# Access Compliance Report

## Public Rights-of-Way

### (Curb Ramps)

Intersection ID: 18932	Main Street: GLENHAM_DR	Cross Street: TYVOLA_RD	Location: SE
ADA ID: D778AF6E516E	Ramp Type: Perp	Initial Pass/Fail: Fail	Overall Compliance: No
Severity Score: 33.75			
Codes/Mitigation Info/Possible Solution		Field Measurements/Component Compliance

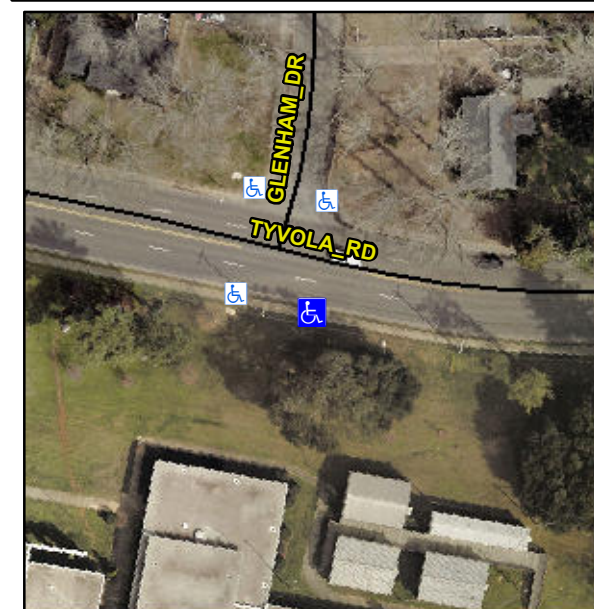
**R304.5.1, R304.2.2**

Compliance	Description	Data	Compliance	Description	Data
N/A	Ramp Length (in)	66.0	No	Ramp Slope (%)	12.9
No	Ramp Width (in)	39.0	Yes	Ramp XSlope (%)	1.9
N/A	Flare Type LT	N/A	N/A	Flare Type RT	N/A
N/A	Flare Slope LT (%)	N/A	N/A	Flare Slope RT (%)	N/A
N/A	Flare Traversable LT?	N/A	N/A	Flare Traversable RT?	N/A
N/A	Landing Length (in)	N/A	N/A	DWS Provided?	N/A
N/A	Landing Width (in)	N/A	N/A	DWS Contrast?	N/A
N/A	Landing Slope (%)	N/A	N/A	DWS Length (in)	N/A
N/A	Landing X Slope (%)	N/A	N/A	DWS Full Width?	N/A
N/A	Landing Curb? (Y/N)	N/A	N/A	DWS Offset (in)	N/A
N/A	Shared Landing?	N/A			
N/A	Gutter Ponding?	N/A	N/A	Gutter Slope (%)	N/A
N/A	Gutter Lip Ht (in)	N/A	N/A	Gutter X Slope (%)	N/A
N/A	Painted X Walk1?	No	N/A	Painted X Walk2?	N/A
	X Walk 1 Direction	To N		X Walk 2 Direction	N/A
N/A	X Walk 1 Width (in)	N/A	N/A	X Walk 2 Width (in)	N/A
	X Walk 1 Slope (%)	6.2		X Walk 2 Slope (%)	N/A
	X Walk 1 X Slope (%)	0.1		X Walk 2 X Slope (%)	N/A

**Remove & Replace Entire Ramp.**
